PZ Report - September 26, 2017

Conduct a Public Hearing to Consider/Discuss/Act on a Request to Rezone the Subject Property from “PD” – Planned Development District to “PD” – Planned Development District, Generally to Allow Commercial, Single Family Attached Residential and Multi-Family Residential Uses, Located on the Southwest Corner of Eldorado Parkway and Stonebridge Drive

4th Redlines - September 15, 2017

ZONING EXHIBIT

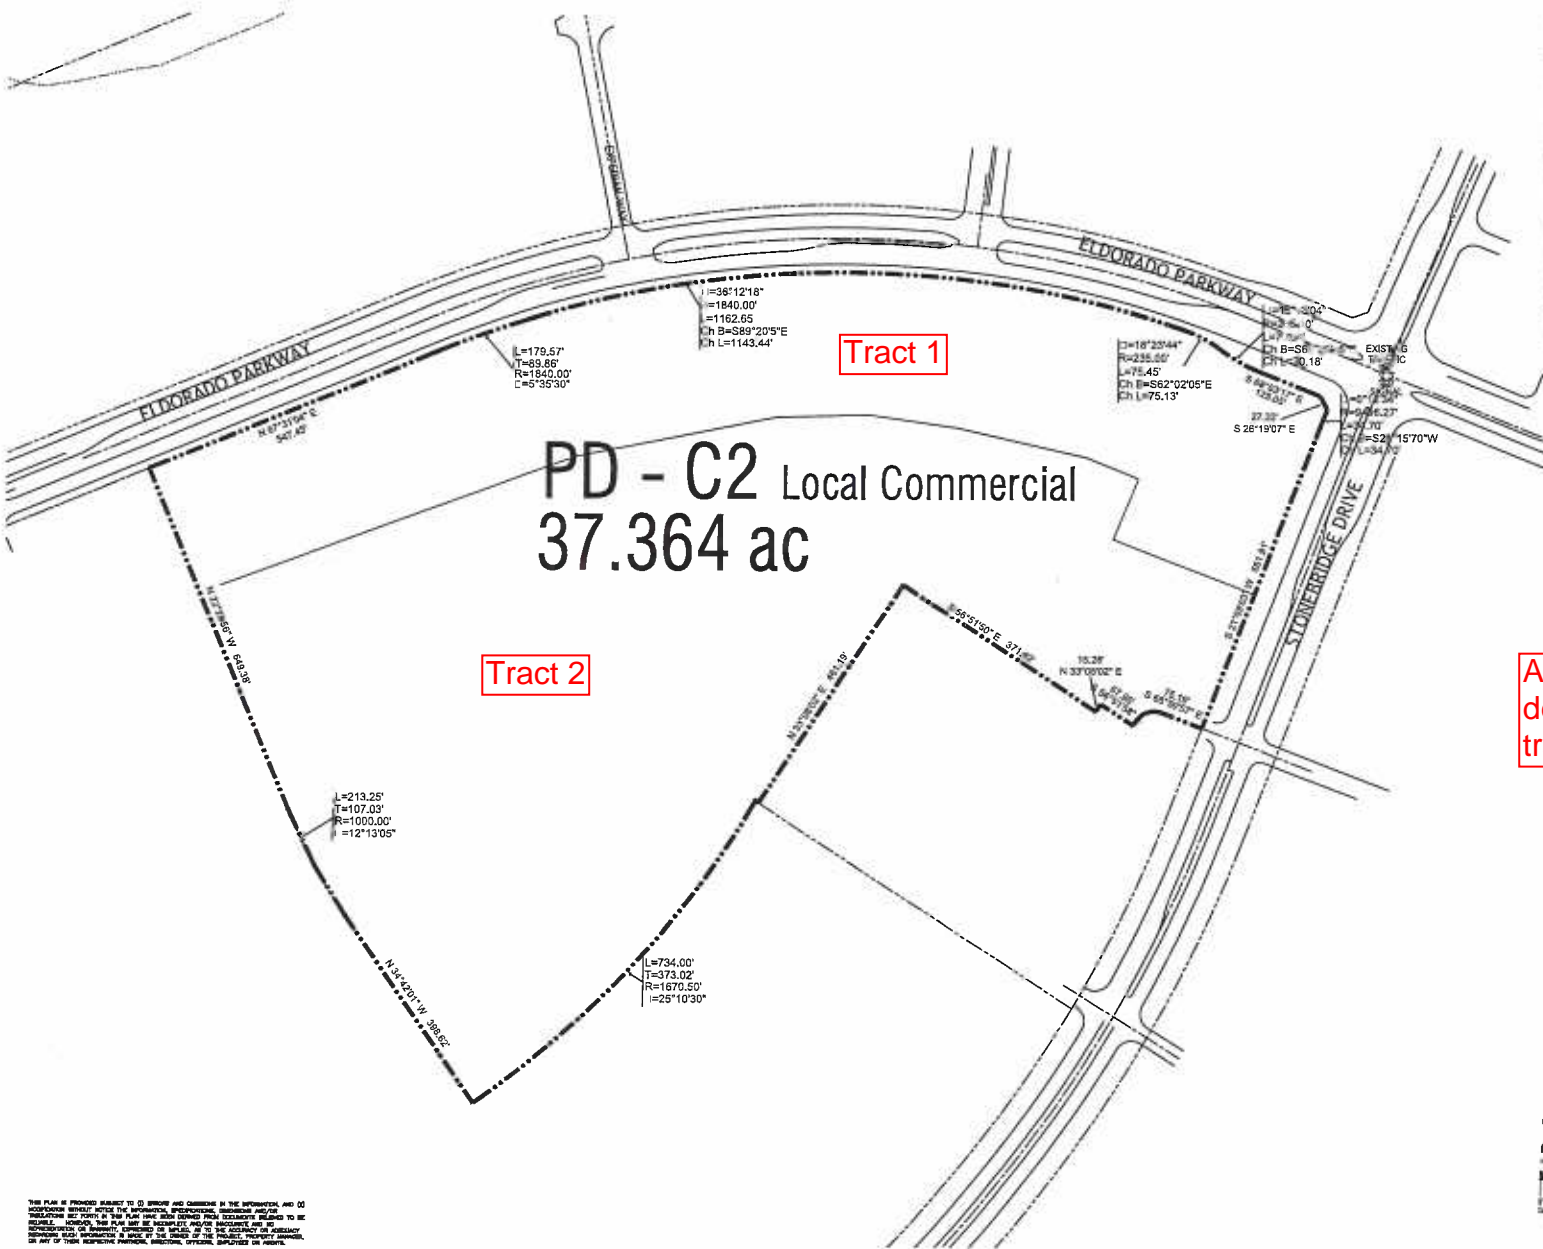
Commented [A5]: Specify type. Pavers are not permitted, Is this to be stamped concrete? The City enforces specific design criteria for stamped concrete, please see below: The standard detail for stamped concrete is a 90 degree herringbone pattern, colored antique red.
